Applicant Outreach Summary

The Harriet on Riley Park

LOC2025-00133

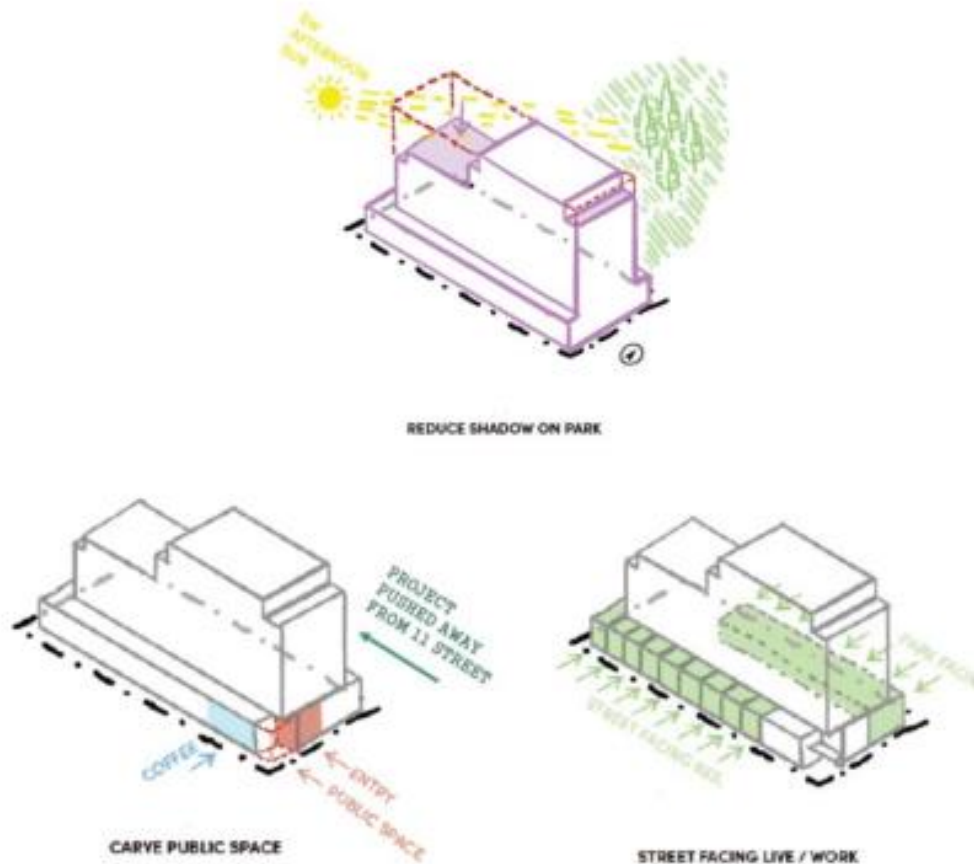
Concerns regarding building height, massing, and shadow impacts on Riley Park were a central theme throughout engagement. In response, the massing strategy evolved from an earlier tower-based approach to a more articulated form that steps from lower heights adjacent to the park up to greater height toward the east.

The current massing places approximately eight storeys along the western edge of the site, increasing gradually toward a maximum of twelve storeys on the east side. This approach reduces shadow impacts on Riley Park, improves transition to adjacent development, and establishes a gateway condition at the eastern edge of the park. This gateway massing is intended to align with future development patterns east of 11 Street NW and anticipated public realm improvements along the corridor.

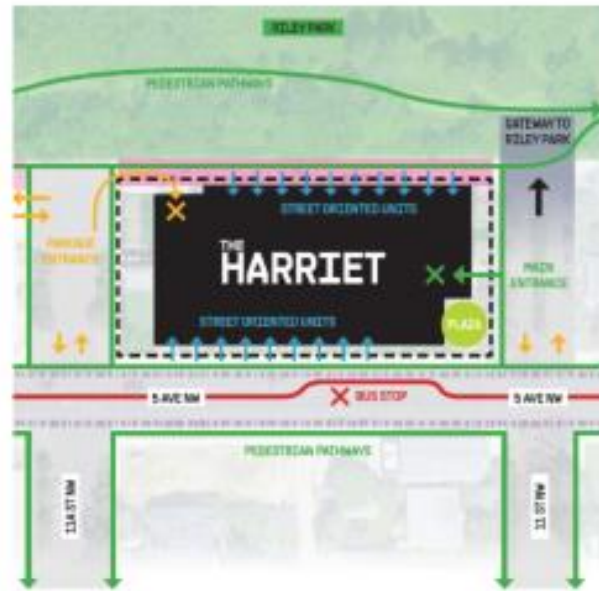
During the second Open House, one participant noted the glass atrium (gym/social area) on top of the eight floor should be noted in elevations and possibly constitutes another storey. The atrium will be glass and significantly set back from all edges on the roof of the eight floor. Elevations will be annotated to indicate this reality.
